**TOWN OF ERIE
BOARD OF TRUSTEES MEETING
Meeting Date: August 14, 2018**

SUBJECT:	A Sketch Plan Review of Parkdale Sketch No. 2, single-family detached and duplex development.
CODE REVIEW:	Erie Municipal Code, Title 10
PURPOSE:	A Sketch Plan represents a generalized land use plan and layout for the area proposed to be included within a subdivision. A Sketch Plan application is required to allow for an early, informal evaluation of a proposed subdivision before detailed planning and engineering work has occurred.
DEPARTMENT:	Planning & Development
PRESENTER:	Audem Gonzales, Planner

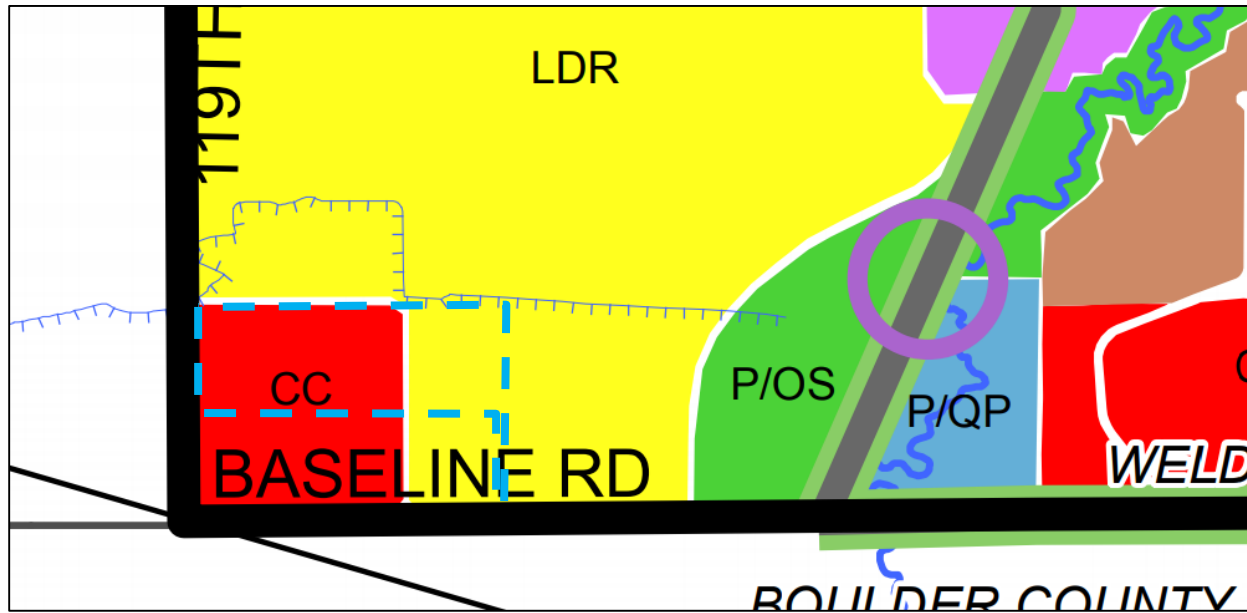
The Parkdale Sketch No. 2 application proposes to add a new area of development to the Parkdale subdivision. A collector road heading east from 119th Street provides access to the residential subdivision. This collector will also provide a connection for commercial development to the south. The sketch plan also incorporates several road stubs to adjacent properties that could develop in the future.

The development proposes two single-family detached lot types and one paired home lot type. Each home is proposed to be alley-loaded. Where homes do not have street frontage the applicant has provided 30-foot wide garden courts.
